Florida Power & Light Company  
St. Lucie Unit 2  
Docket No. 50-389

Subject: Response to NRC Request for Additional Information

**Individual Responses to NRC RAIs for FPL Generic Letter GL 2004-02  
Supplemental Responses, Dated 02/27/2008 and 06/30/2008**

Figure 16-1 Note that a portal at azimuth 180 has been omitted

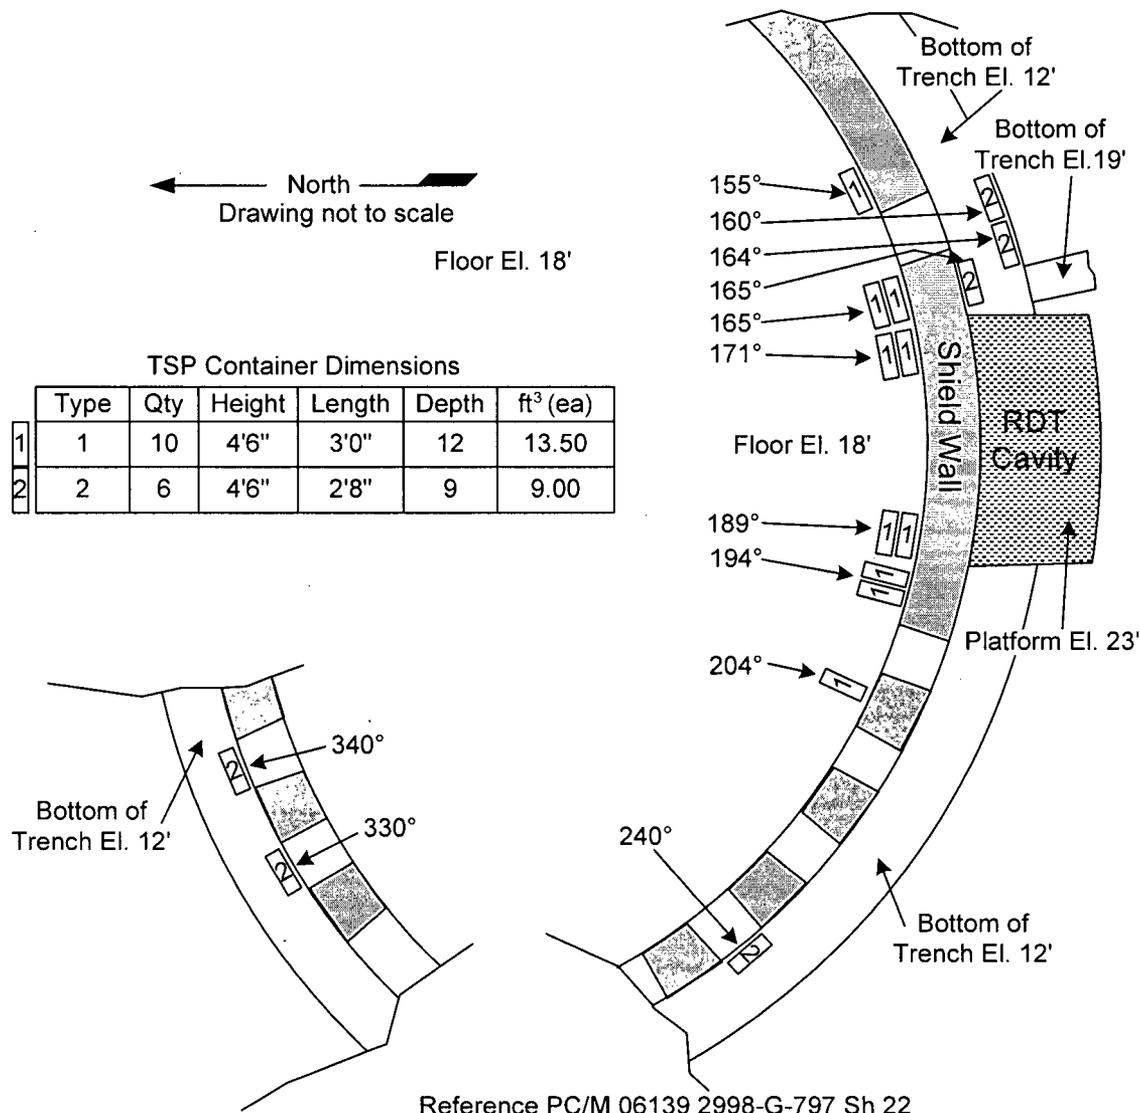
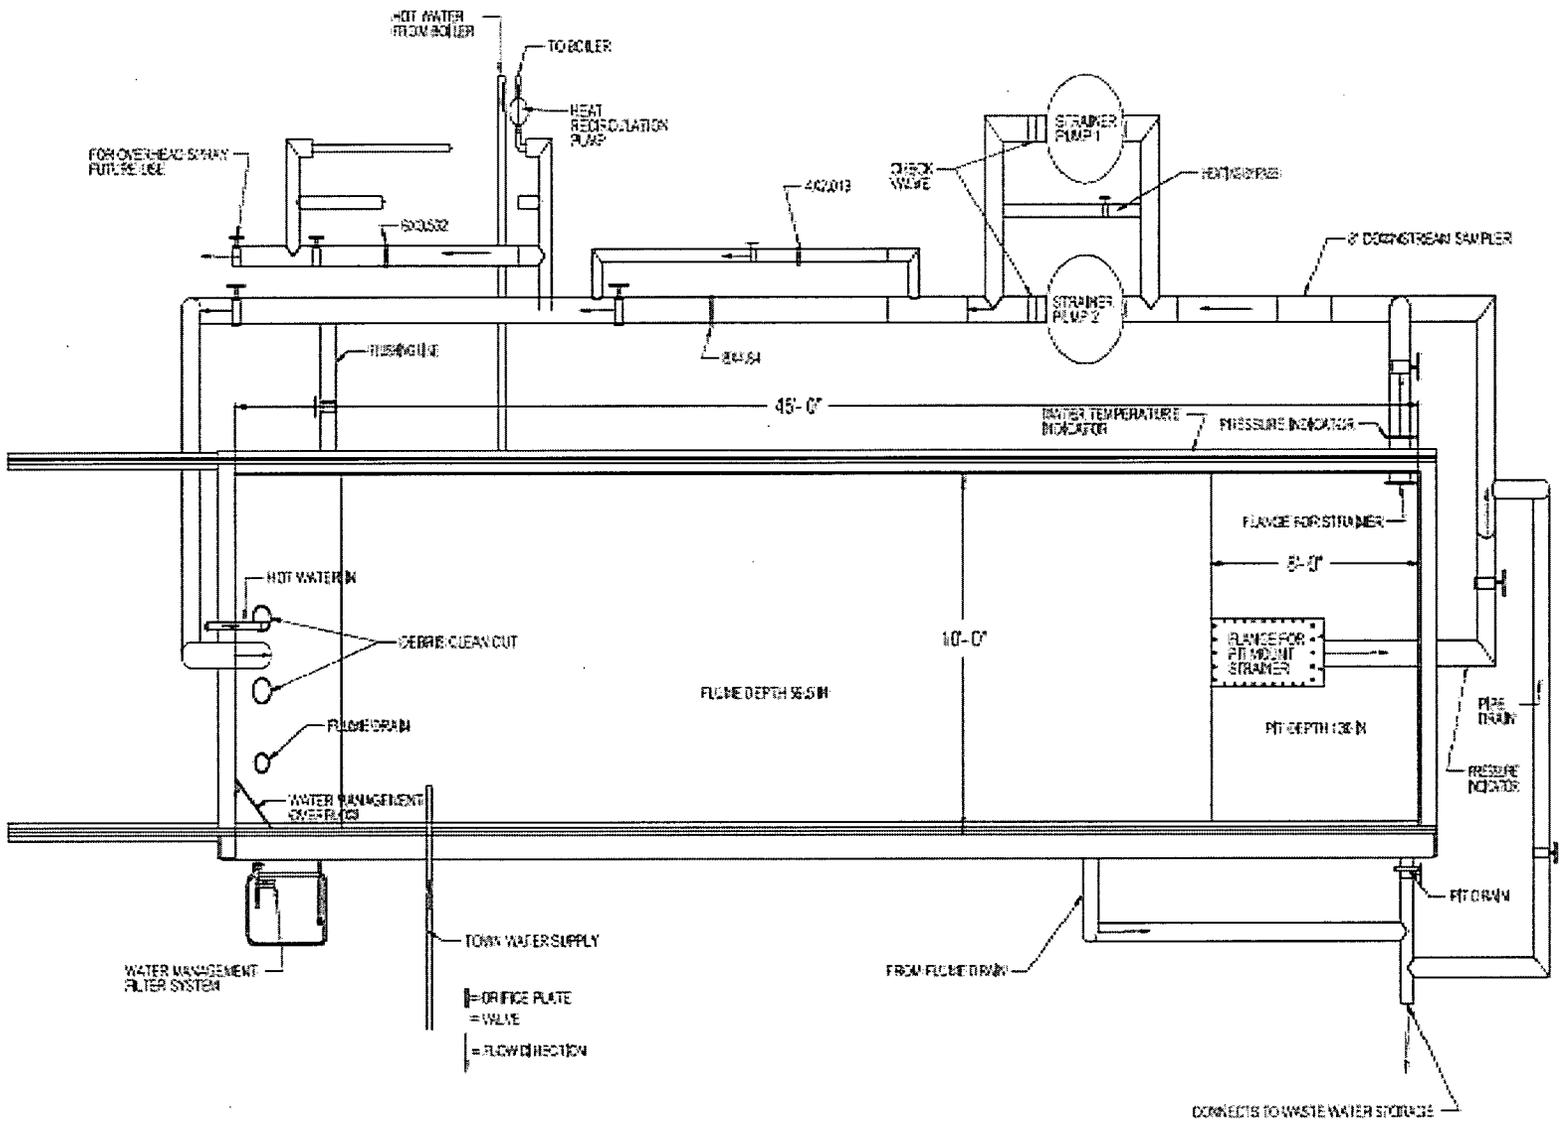
**RAI-16:** Your submittal indicates that the trisodium phosphate (TSP) is stored in sixteen open baskets in the vicinity of the containment sump. Discuss the distance from the various TSP baskets to the sump strainer relative to the distance in the Alden flume from the chemical precipitate addition point to the test strainer. Given the more rapid settling characteristics for calcium phosphate precipitate, justify why the transport of calcium phosphate in the test flume is conservative relative to the plant. The staff notes that there is uncertainty concerning where calcium phosphate would form as both calcium silicate insulation fines and TSP will dissolve in the post-LOCA pool.

**RAI-16 RESPONSE:** The St. Lucie Unit 2 TSP containers are of two sizes, type 1 and type 2, and are arranged both within and outside of SBS wall (see Figure 16-1). Ten 13.5 cubic foot containers are within the SBS wall and six 9 cubic foot containers are outside the wall and located inside the ECCS trench at various distances from the ECCS/CSS strainers. The six smaller containers were relocated from the sump pit (reactor drain tank (RDT) cavity) to make room for the new strainers. Thus, the majority of the TSP volume is on the opposite side of the SBS wall from the ECCS/CSS strainers and requires significant approach and flow direction changes to reach the strainers.

The test apparatus consisted of a steel flume measuring 10' wide, 5' deep (with a 6' deep pit) and 45' long (see figure 16-2). Inside of the steel flume, plywood was used to contour the flume walls to simulate the containment approach velocities. The upstream most portion of the flume was used to introduce the flow into the flume resulting in a 35.46' test section. The introduction of chemicals and debris is in accordance with the agreed upon protocols by the NRC, at the drop zone. If the calcium phosphate partially settles in the flume, then it will settle in the

Figure 22b-1: Generic Test Flume Configuration (Top View)

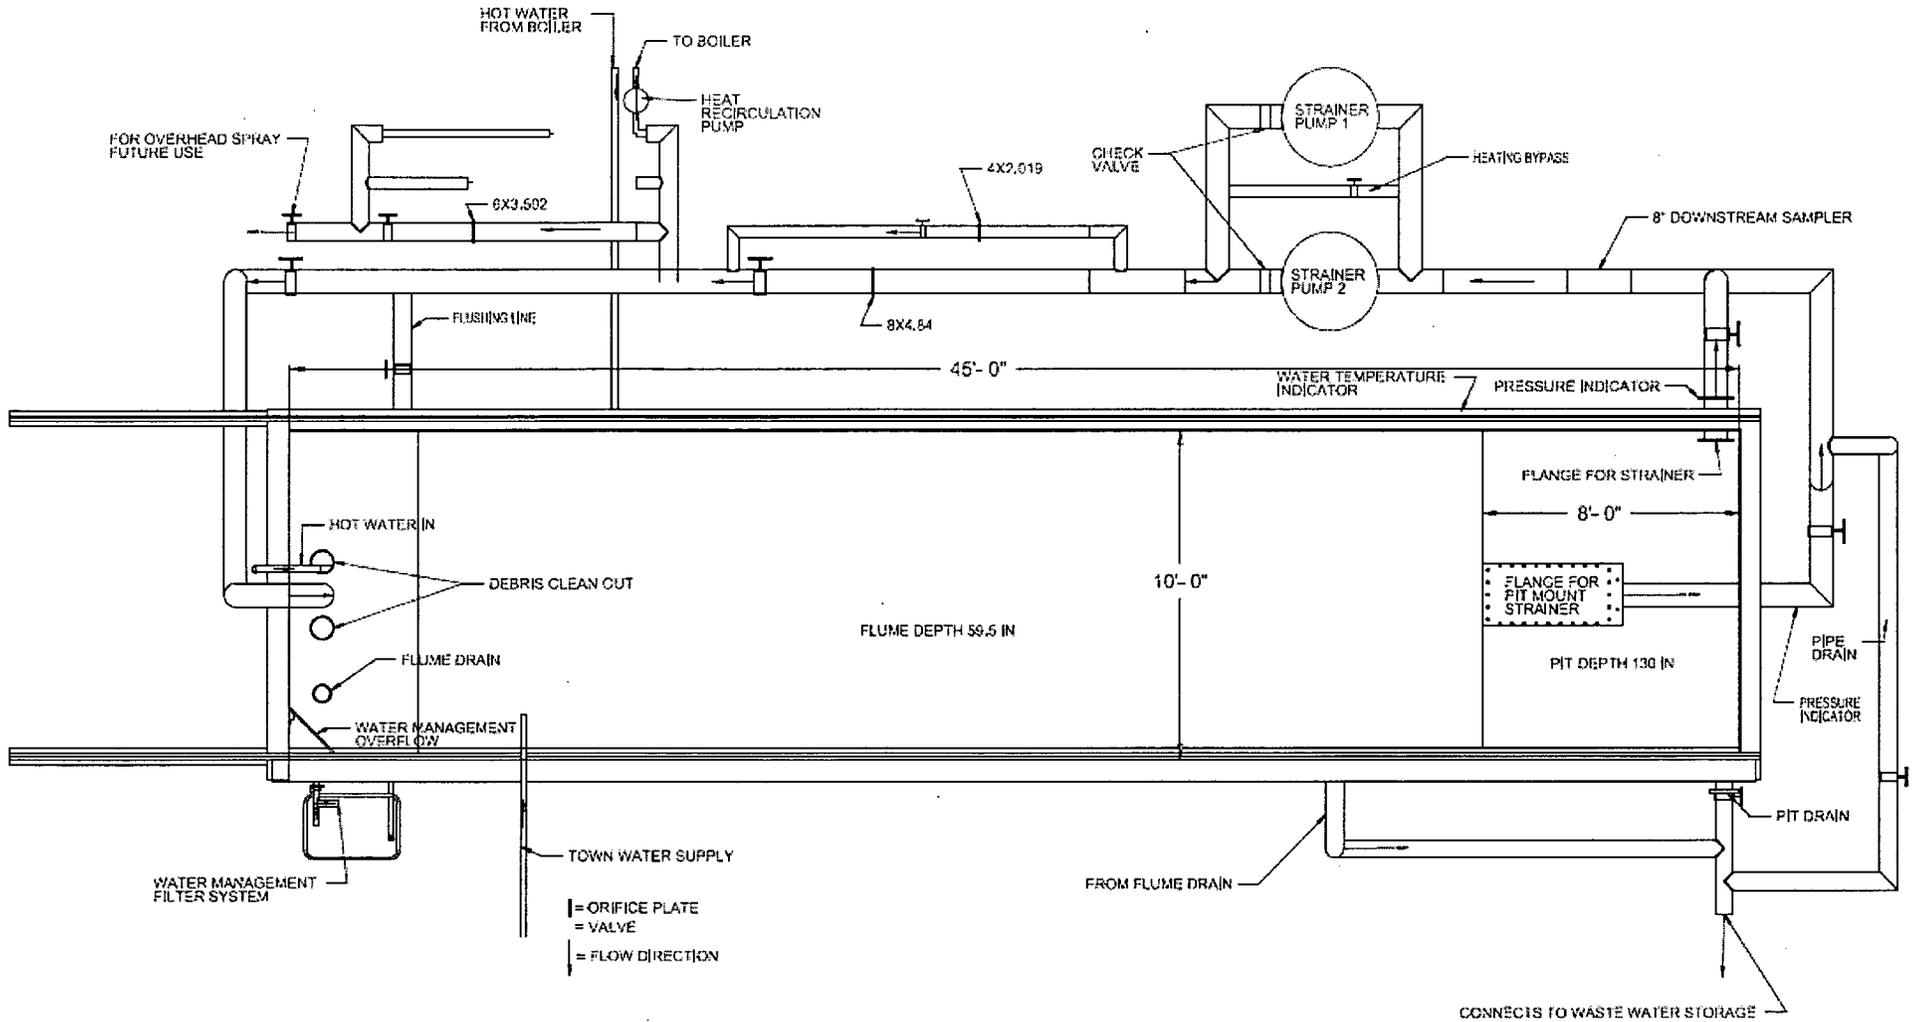
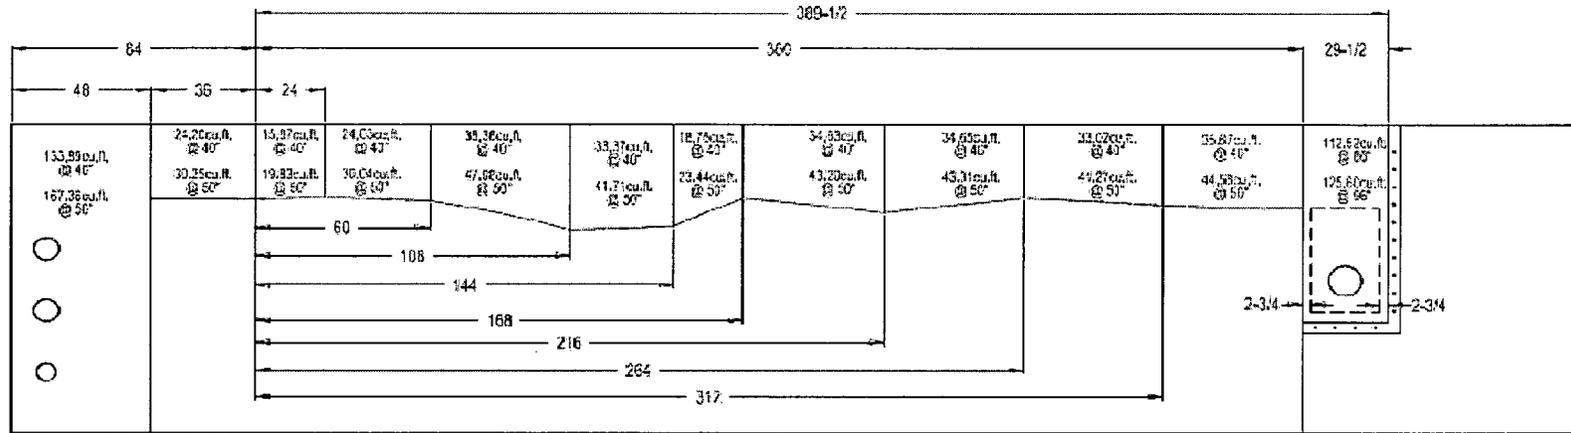
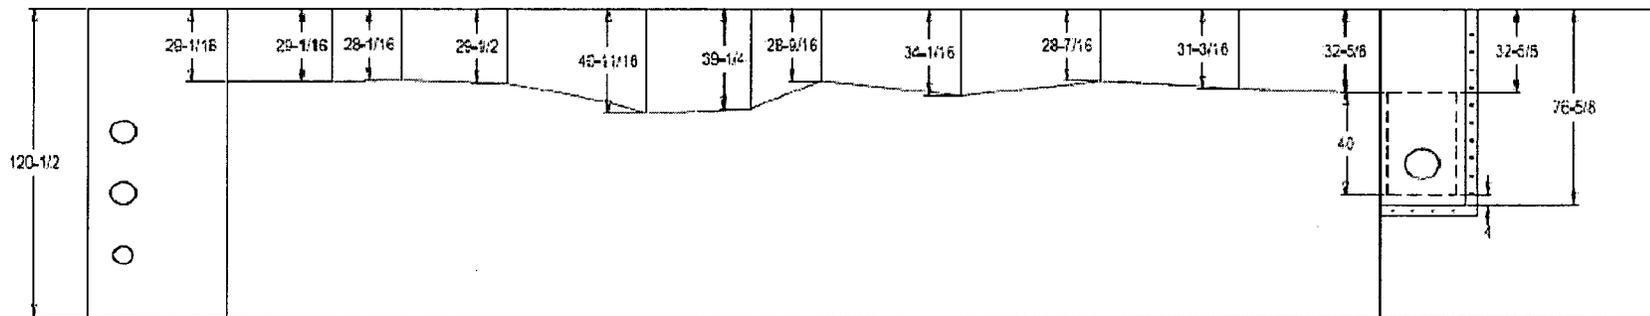
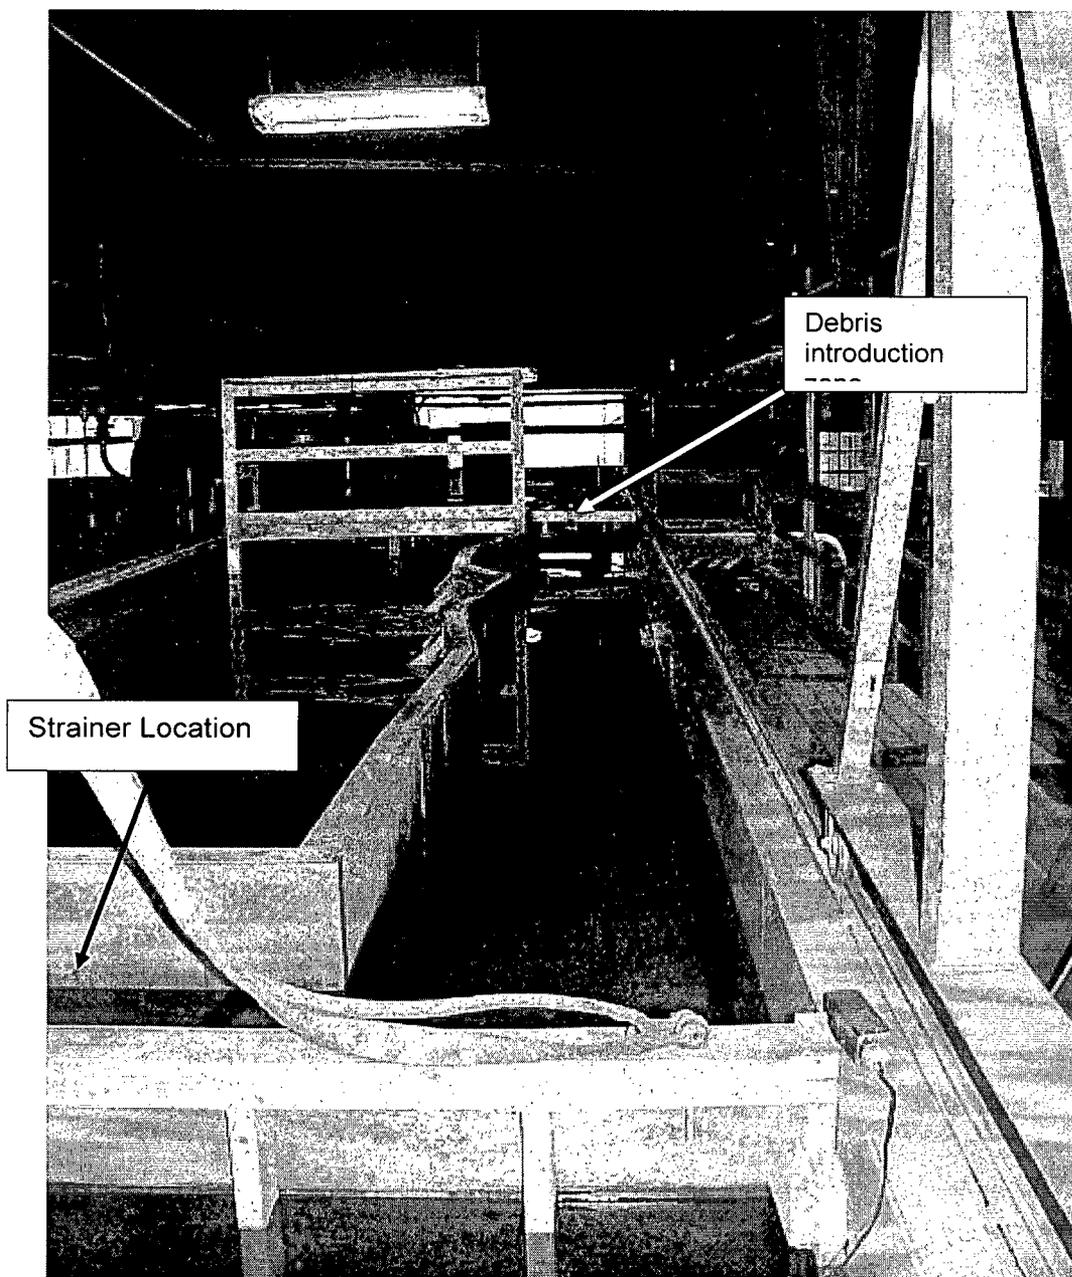
Provide documentation of the head loss testing methodology, including;  
Description of test facility.

The test apparatus includes a test flume, two pumps (a main operating pump and a back up pump if the main pump fails. Both pumps do not operate in parallel), a prototype strainer, instrumentation & controls, and the associated piping and valves needed to complete a recirculation loop. The chemical injection system consists of; chemical mixing tanks, a peristaltic pump designated to pump the chemical debris into the test flume, and associated piping/tubing. To conservatively maintain a steady water level at or below the submergence water level during testing, an over flow weir (water management overflow Figure 22b-1) was installed at the upstream end of the test flume. Debris which may have transported past the overflow weir was captured by 5 and 10 micron bag filters located downstream of the overflow weir.

Figures 22b-1 through 22b-3 below depicted the test configuration utilized for St. Lucie Unit 2.

Figure 22d-1: Flume Configuration.

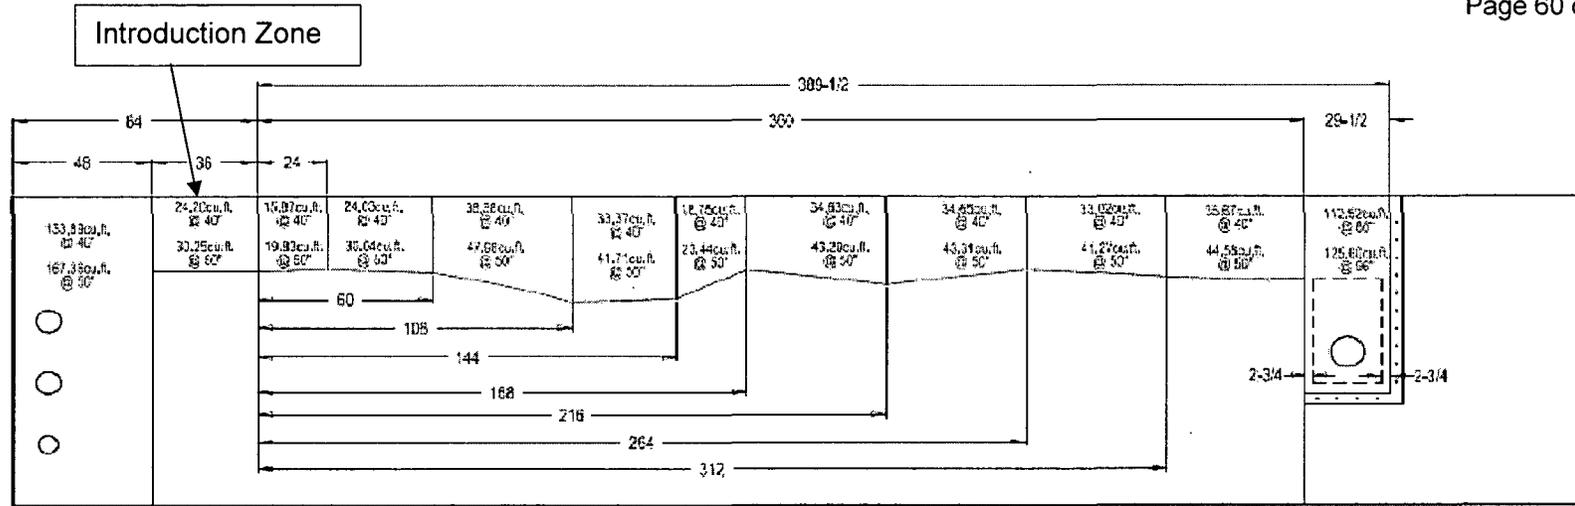
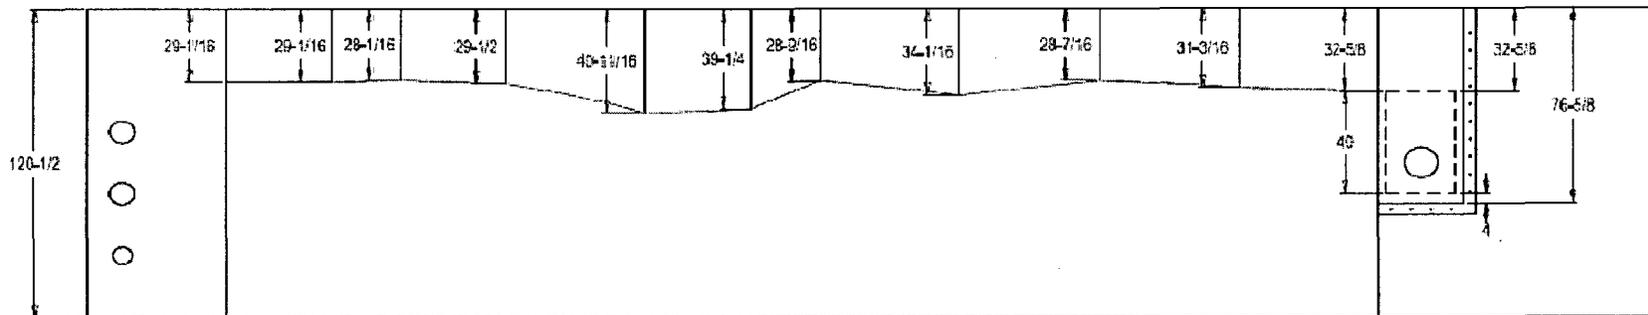
**RAI-22d:** Provide documentation of the head loss testing methodology, including; Debris introduction zones.

Batch 1, 25% latent fiber, was introduced along the length of the test flume. All other debris batches, were introduced into the test flume at the drop zone. See Figure 22d-1, below. The introduction zone was 389-1/2" inches upstream of the strainer module. The chemical debris was also introduced to the flume at the introduction zone indicated on Figure 22d-1 below.
